Historic Architectural Review Commission Staff Report for Item 6

Meeting Date: May 24, 2022

Address: #418 United Street

Demolition of a partial first-floor porch enclosure on southeast corner of house.

**EXISTING PARTIAL PLAN
FIRST FLOOR**
SCALE: 3/16" = 1'-0"

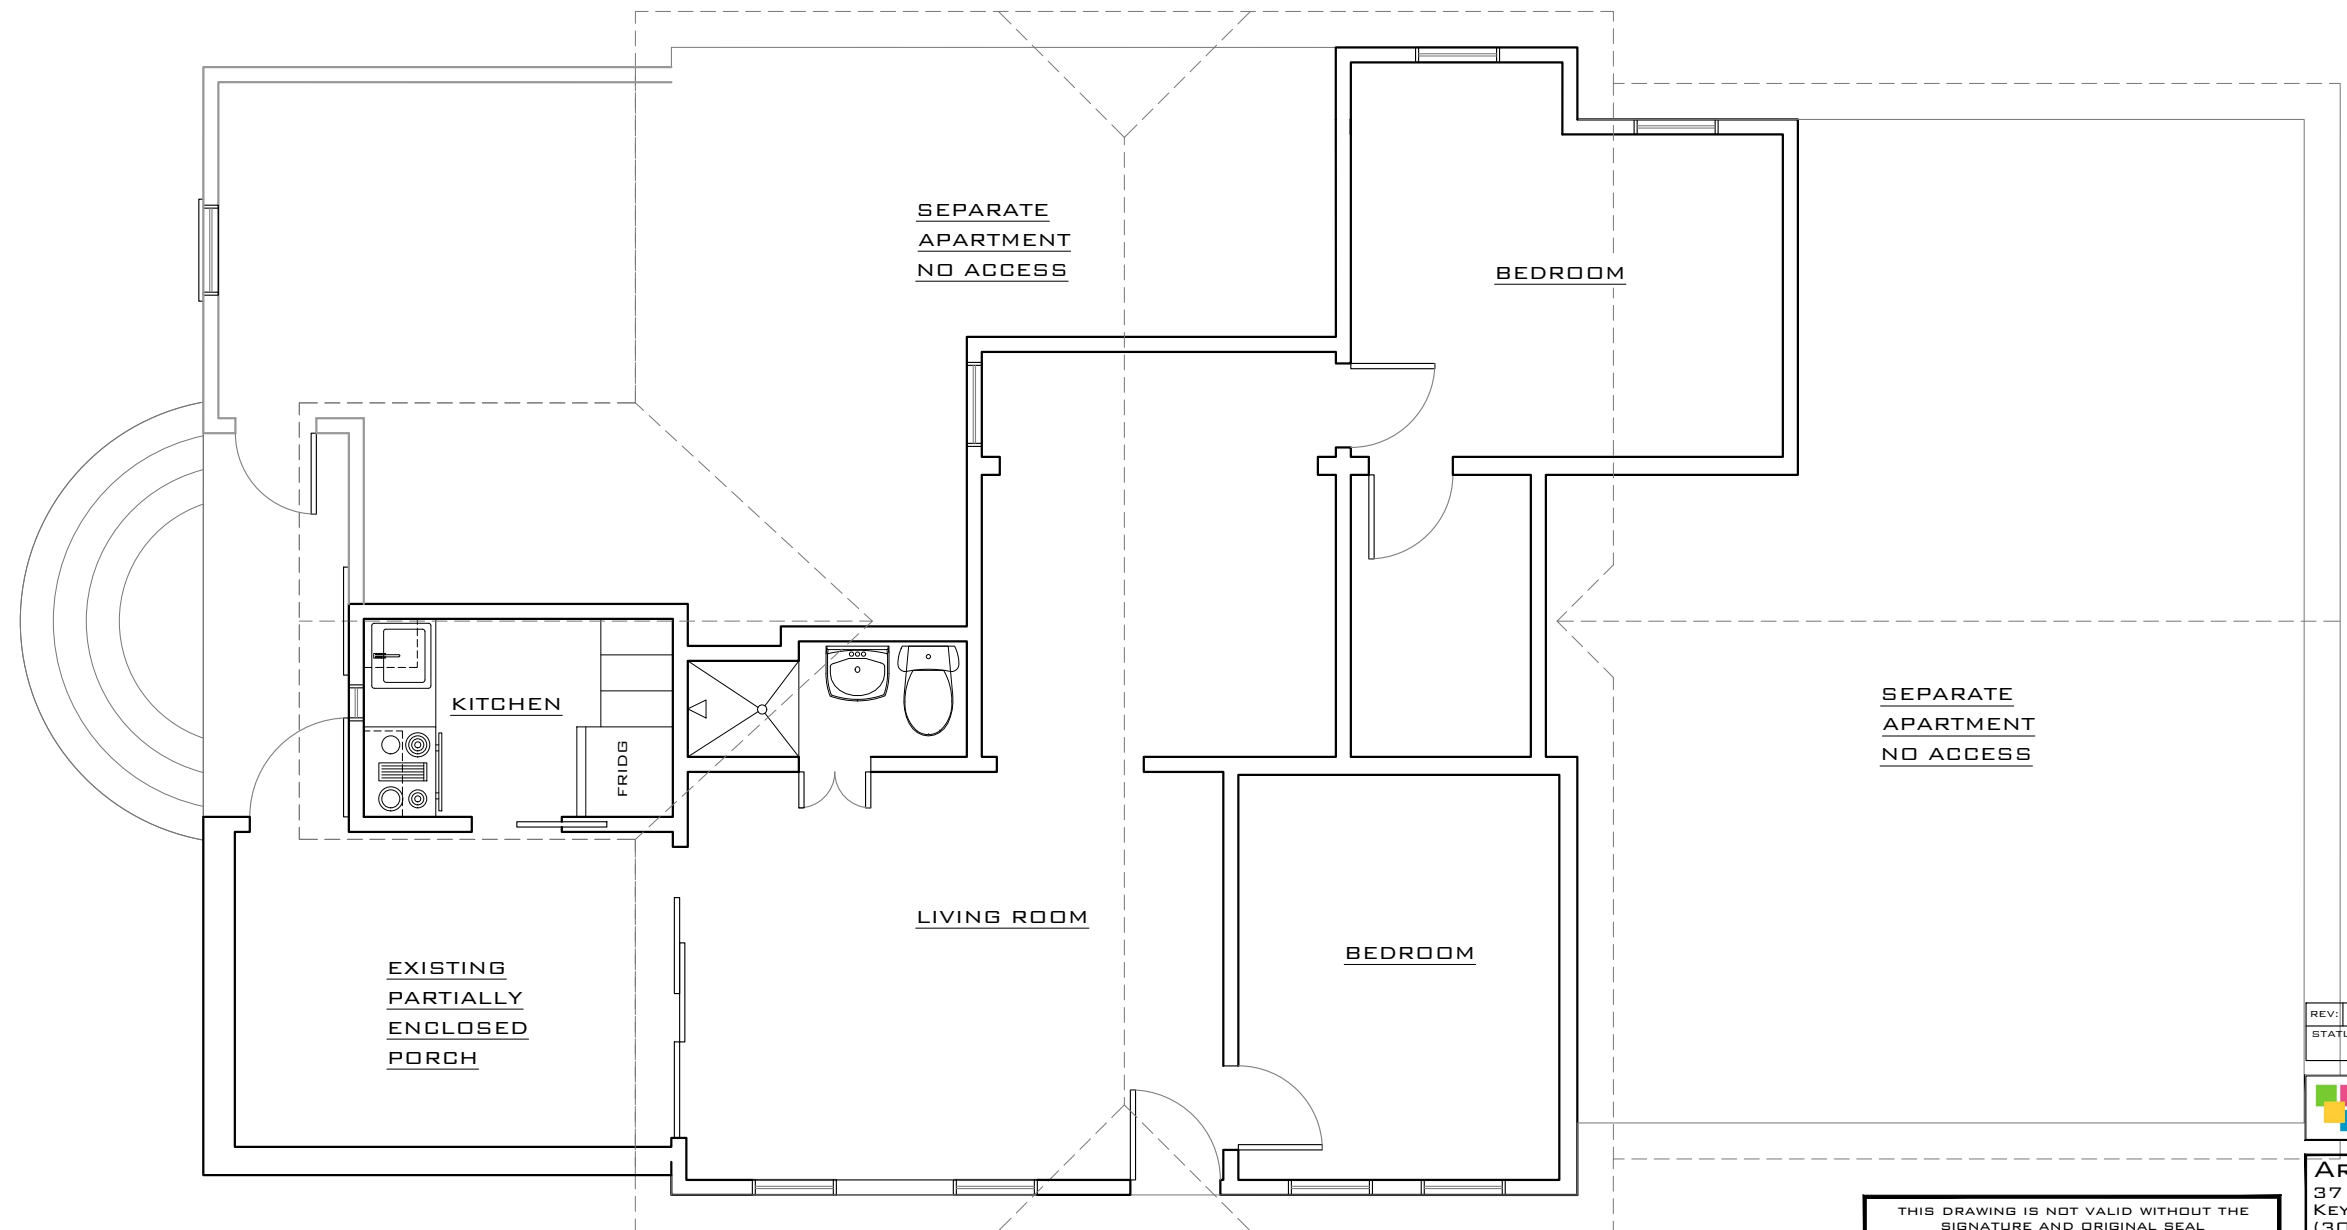
The Certificate of Appropriateness under review proposes the demolition of the first-floor porch enclosure on the southeast corner of the house at 418 United Street. The partial enclosure is not historic and was likely constructed without building permits.

A proposal to fully enclose the southeast corner of the porch on the first floor (in place of the existing partial enclosure) is under review as part of this application, but it was determined by staff to be against the HARC guidelines for Additions and Alterations.

It is staff's opinion that the removal of the partial enclosure will not have a negative effect on the character of the surrounding neighborhood.

The partial enclosure is non-historic.

The partial enclosure under review has not acquired historic significance that is important to the site or surrounding district.

It is staff's opinion that the partial enclosure in question will not qualify as a contributing element to the site or to the historic district in the near future.
